Work Order ID 70785

Item Name: 205 Skidtube bent detail

DRAWING NO. D2580	TITLE 205 SKIDTUBE ASSEMBLY	REV. D	DART AEROSPACE LTD ENGINEERING ORDER		D.E.O. NO. D2580-D-1	SHEET NO. SHEET 1 OF 1	SCALE NTS
DRAWN UP	CHECKED L	MFG. APPR. E	APPROVED MP		DE APPR. H		
DATE 10.09.22	DATE 10.11.04	DATE 10.11.04	DATE 10/11/04		DATE 10.11.04

PURPOSE:

SECTION D-D & SECTION H-H ARE AMENDED AS FOLLOWS:

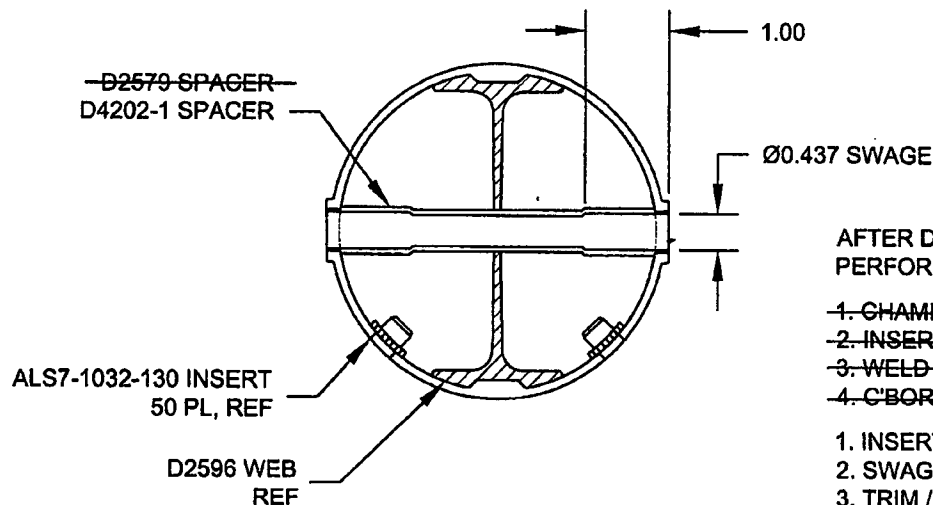
CHANGE ALL WELDED CROSSBOLT SPACERS TO SWAGED SPACERS

AFTER DRILLING AND BENDING ASSEMBLY
PERFORM THE FOLLOWING FOR Ø0.508 HOLES ONLY:

1. CHAMFER HOLE 0.060 X 45°
2. INSERT D2579 SPACER (20 PLACES)
3. WELD INTO PLACE AND GRIND FLUSH
4. C-BORE D2579 SPACER TO Ø0.437 X 1.00 DEEP

1. INSERT D4202-1 SPACER, 20 PL (-041) OR 24 PL (-045)
2. SWAGE TO Ø0.437 X 1.00 DEEP PER QSI 002
3. TRIM / GRIND FLUSH PER QSI 002
